SUBJECT: Forwards response to 840817 request for addl info re
 NUREG-0737, Item III.D.3.4, "Control Room Habitability."

Subject: Oconee Nuclear Station
Docket Nos. 50-269, -270, -287
Response to Request for Additional Information
NUREG-0737 Item III.D.3.4
Control Room Habitability

Duke Power Company
Response to NRC Request for Additional Information
Control Room Habitability - Oconee Nuclear Station

ATTACHMENT 1

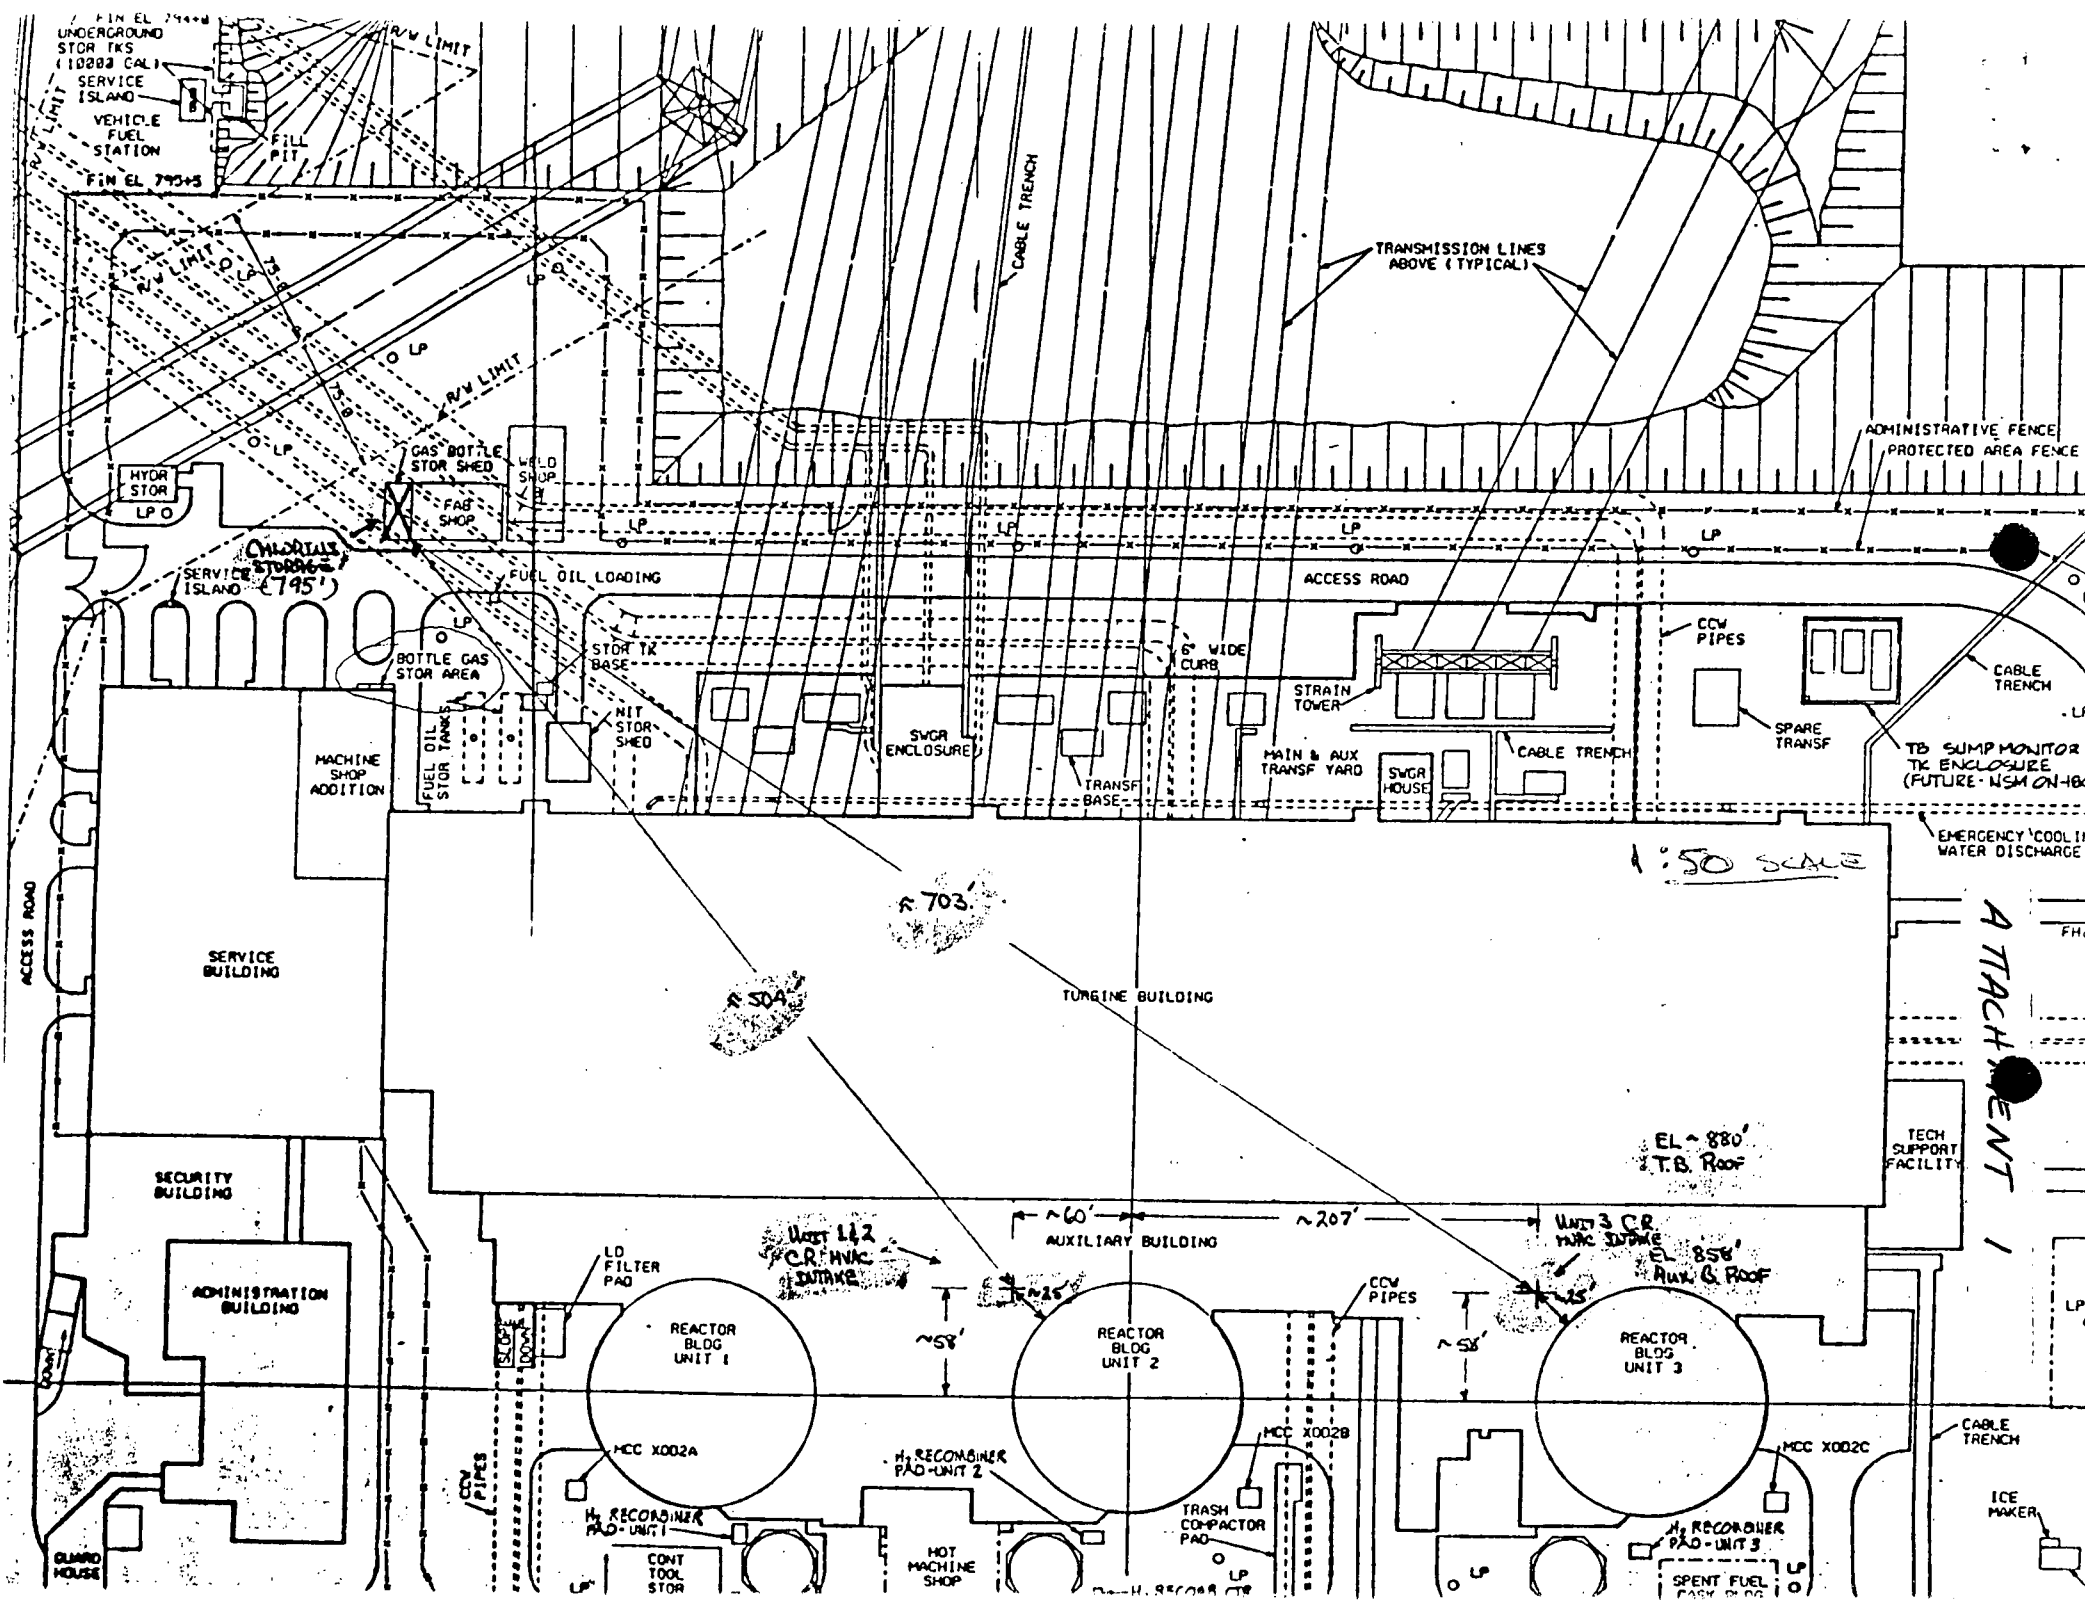
- 3). With the completion of the proposed modifications, failure of one of the 50 percent capacity outside air filter trains would result in a reduced capacity to maintain control room pressurization, but would not eliminate a pressurized control room. With the single outside air handling unit supplying positive pressurization flow, the unfiltered inleakage rate should not significantly deviate from that previously assumed, i.e., 10 cfm.
- 4). Provide justification for the filter efficiency assumed in the dose calculation if dehumidification, at a location upstream of the emergency filters, is not part of the design.
